Subject: Amendment No. 6 to Facility Operating License No. NPF-14 -
 Susquehanna Steam Electric Station, Unit 1

ATTACHMENT TO LICENSE AMENDMENT NO. 6
FACILITY OPERATING LICENSE NO. NPF-14
DOCKET NO. 50-387

SAFETY EVALUATION
AMENDMENT NO. 6 TO LICENSE NPF-14
SUSQUEHANNA STEAM ELECTRIC STATION; UNIT 1
DOCKET NO. 50-387

Bases Figure B 3/4 3-1
 REACTOR VESSEL WATER LEVEL

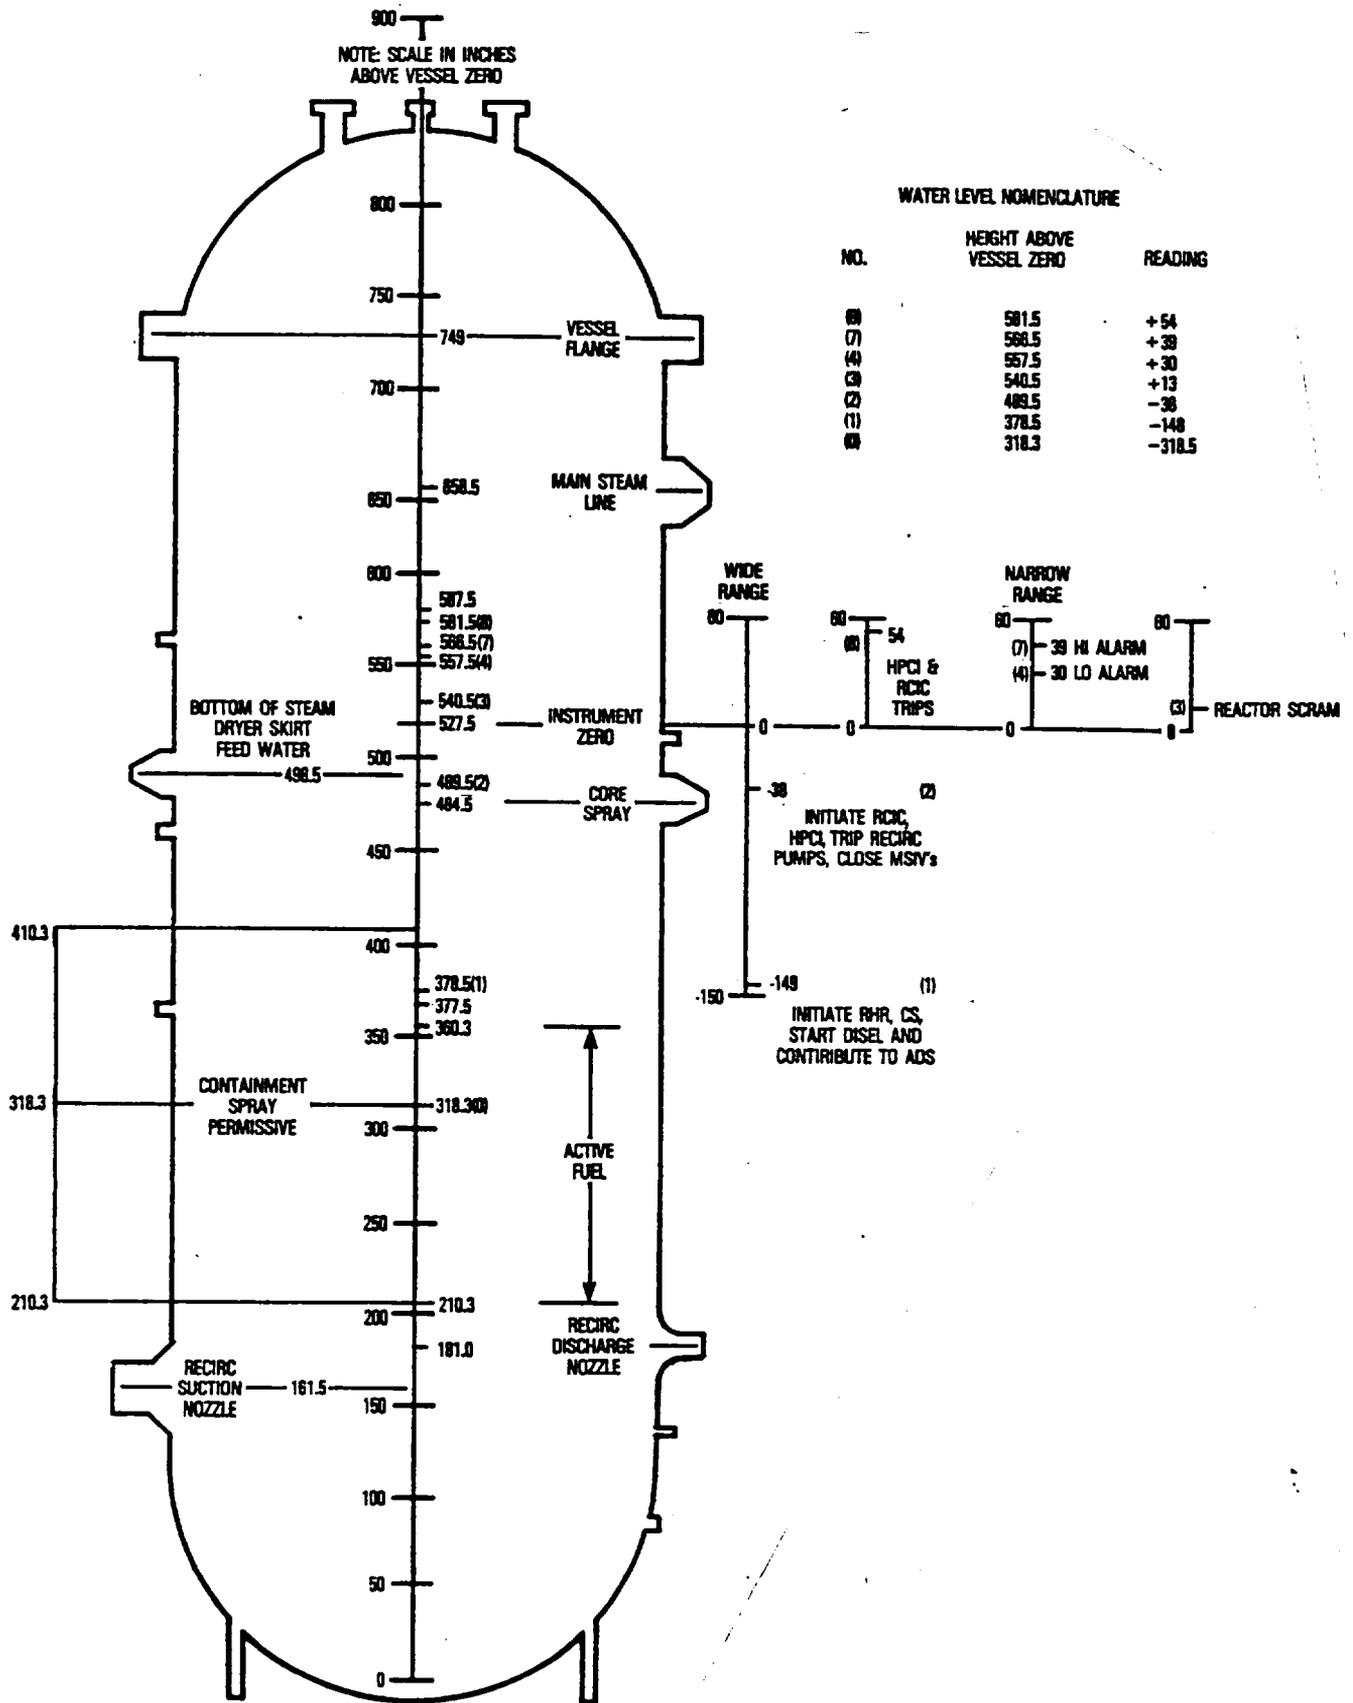
Page B 3/4 3-8

Under Water Level Nomenclature, change "WEIGHT ABOVE VESSEL ZERO" to read "HEIGHT ABOVE VESSEL ZERO".
